**PUBLIC HEARINGS AND MEETINGS
 PLANNING AND DEVELOPMENT REPORT TO COUNCIL
 SITE SPECIFIC AMENDMENT
 February 19, 2025
 To be heard at: 10:00 AM**

APPLICATION INFORMATION		File No. 25R007
	LEGAL DESCRIPTION: Ptn. SE 27-20-29 W4M; Plan 2210304, Block 8, Lot 18	
	LANDOWNER: Amy Dunham	
	AGENT: Timbercreek Homes Inc.	
	AREA OF SUBJECT LANDS: 0.8 acres	
	CURRENT LAND USE: Residential Community Sub-district 'A'	
PROPOSAL: Site Specific Amendment to Section 13.4.6.4 – <i>Utility Servicing Criteria</i> of the Residential Community District to allow for the existing non-compliant on-site wastewater holdings tanks to remain instead of installing the required tertiary treatment system on the subject parcel.		
DIVISION NO: 7	COUNCILLOR: R.D. McHugh	
FILE MANAGER: Brittany Domenjoz

Application proposing a Site Specific Amendment to Section 13.4.6.4 – *Utility Servicing Criteria* of the RC District to allow for the existing non-compliant on-site wastewater holdings tanks to remain instead of installing the required tertiary treatment system on the subject parcel.

MAP 2 - SITE PLAN

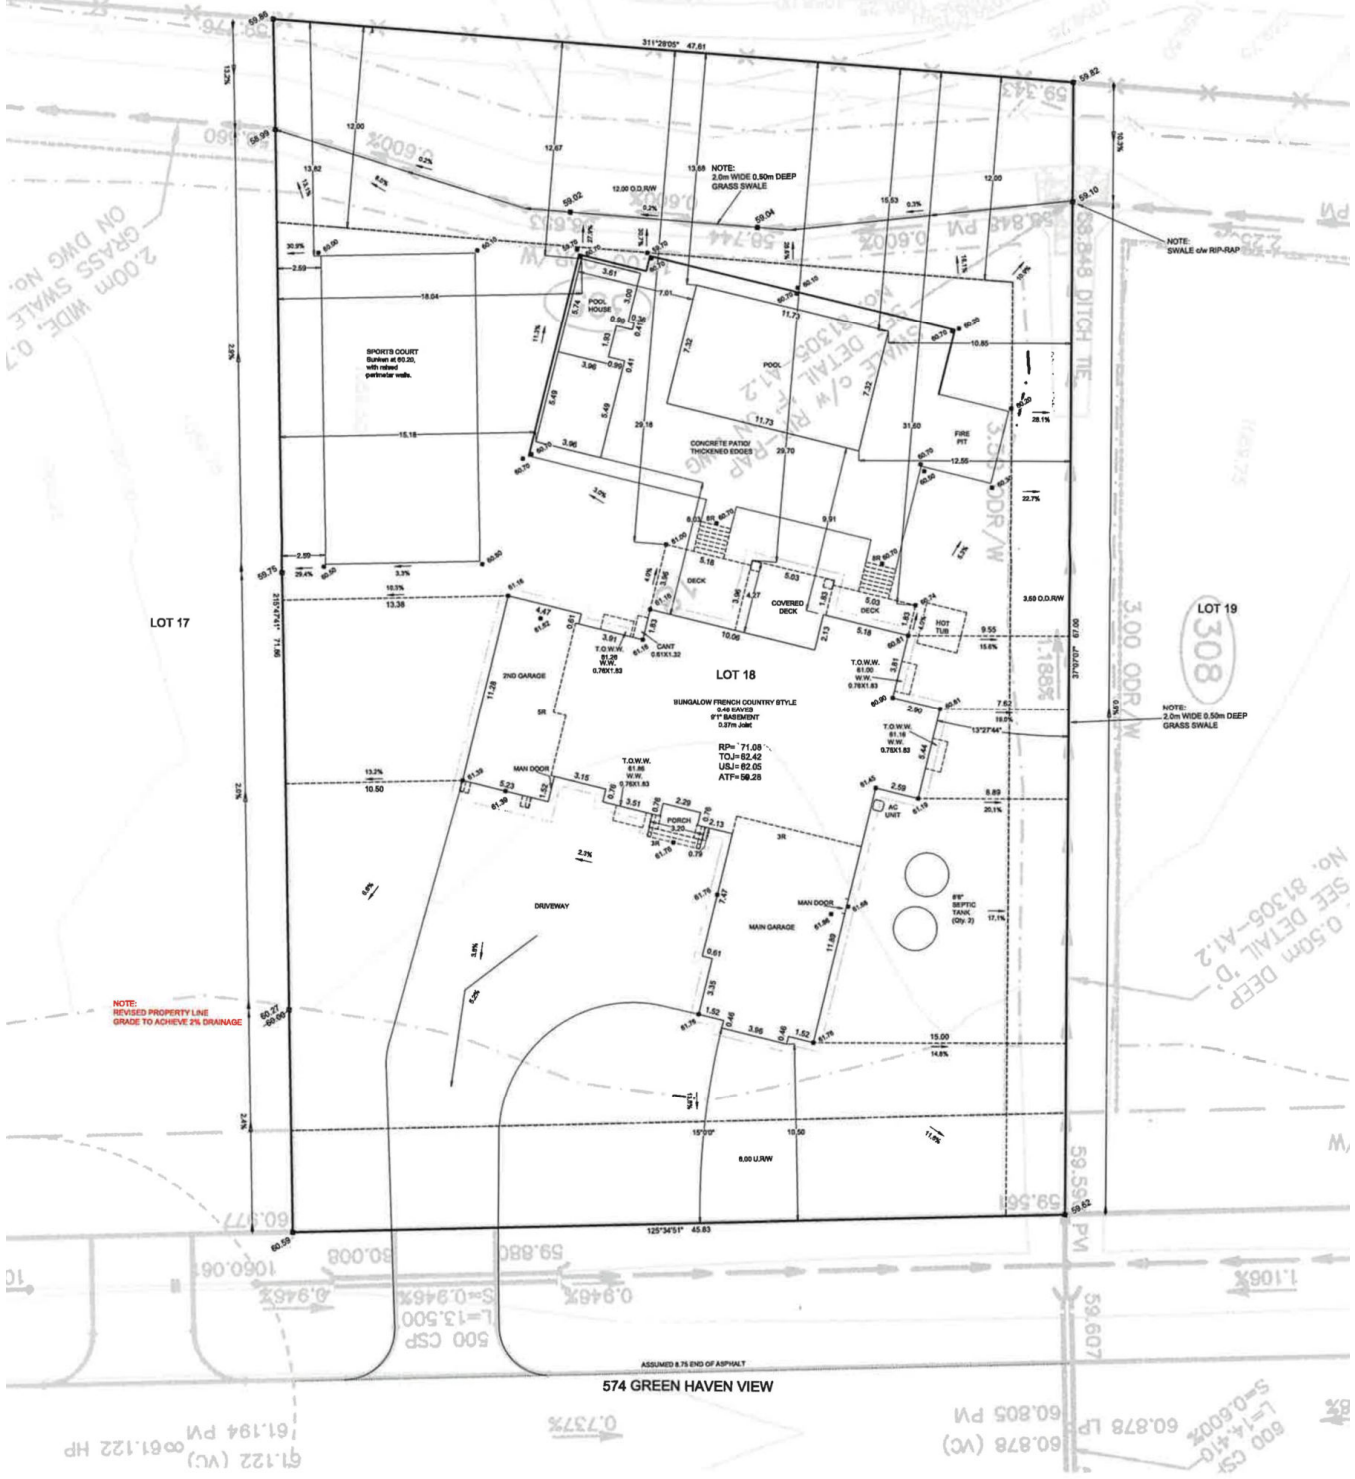
The application was circulated to all internal and external agencies. The Public Works department has reviewed the onsite wastewater evaluation report and provided that if the contractor/builder would have followed the Level 4 PSTS there would have been space for the correct treatment system to be installed as well as space for a back up system in case of failure however this may no longer an option due to the large excavation and disturbed soils at the back of the lot and the installation of the tanks in the NW corner. Further, the Town of Okotoks provided that they have no comment on the application.

Public works provides that the Phase 2B Level 4 PSTS was completed as a design to follow during construction and is to guide the potential layout of the required PSTS area. If the contractor/building would have followed the PSTS there would have been space for the correct treatment system to be installed as well as space for a back up system in case of failure. The department has reviewed the onsite wastewater evaluation report and notes that the report was done post construction, excavation and soil disturbance of the rear yard; therefore, there was the potential for the correct treatment system to be installed however this may no longer an option due to the large excavation and disturbed soil at the back of the lot. The onsite wastewater evaluation report and plot plan showing the measurements are attached as Appendix B.

CIRCULATION REFERRALS	
REFEREE	COMMENTS
INTERNAL	
Public Works	<p>Public Works provided the following comments:</p> <ul style="list-style-type: none"> • Concerns with pump out tanks include additional heavy traffic on the road system. • The level 4 PSTS was completed as a design to follow during construction and give guidance on the potential layout of the required PSTS area. If the contractor/builder would have followed the PSTS, there would have been space for the correct treatment system to be installed as well as space for back up system in case of failure. • The evaluation report was done post construction, and excavation and soil disturbance of the rear yard. This report explains why the tanks were chosen. It is important to note that there was the potential for the correct treatment system to be installed. This may no longer an option due to the large excavation and disturbed soil at the back of the lot and the installation of the tanks in the NW corner. Without those disturbances there would have been space for the correct treatment system to be installed in the rear with a potential secondary location along the east or west boundary. • The Level 4 PSTS done for Green Haven used a design flow of 450 igpd. The total area required for subsurface disposal was 232 m2 and an additional 232 m2 required for a secondary reserve area. The evaluation report calculated an additional 71.5 igpd due to additional fixtures. With a peak daily flow of 521.5 igpd, the treatment area required is 252.6 m2.

CIRCULATION REFERRALS	
	<ul style="list-style-type: none"> • To conclude, with the excavated and disturbed soil in the rear of the yard, and the installation of tanks in the NW corner, there is likely no room remaining to install any packaged treatment plant. • If the existing holding tanks are not supported, an engineer’s review of the site would be recommended to determine if there is a suitable location remaining on the site for the required treatment system and secondary back up location.
EXTERNAL	
Town of Okotoks	The Town of Okotoks has no comment on this application.
PUBLIC	
Western Wheel	February 5, 2025 and February 12, 2025
Landowners (half mile)	<p>Notice of this application was mailed to area landowners within one-half mile of the subject parcel on January 29, 2025.</p> <p>1 letter was received prior to the submission of this report and included as Appendix E.</p>
